**Re: Preliminary Site Plan Review Application; Conversion to Residential
Tax Map 1, Lot 32, 35 Badgers Island West
Response to CMA Comments**

On behalf of BIW Inc. we hereby submitted revised plans and supporting material for **Preliminary Site Plan Review Approval** to address the comments from the May 18, 2023, review letter from CMA Engineers. The review was of our April 6, 2023, submission. The Planning Board, at your April 27, 2023, meeting, voted to schedule a Public Hearing for the May 25, 2023, Planning Board. The comments were just received on May 18th. While we understand there is limited time to review our response prior to the meeting, we would like the opportunity to walk the Board through our response at the meeting. The specific comments, repeated below with our responses in bold text, are as follows:

0 DOWNSPOUT SHOE
C4 (AT ALL ROOF GUTTERS) NTS

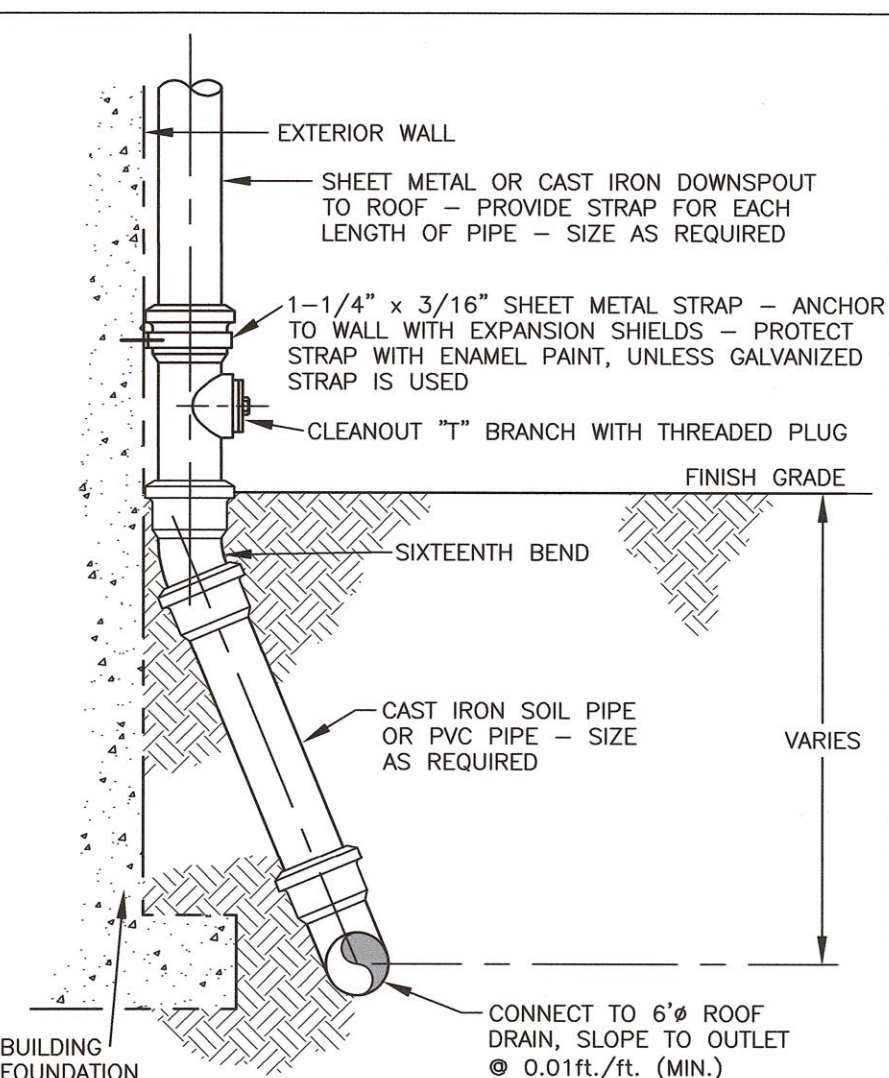
10. What size are the proposed roof drains? Please provide details. **See Detail on Sheet D5.**
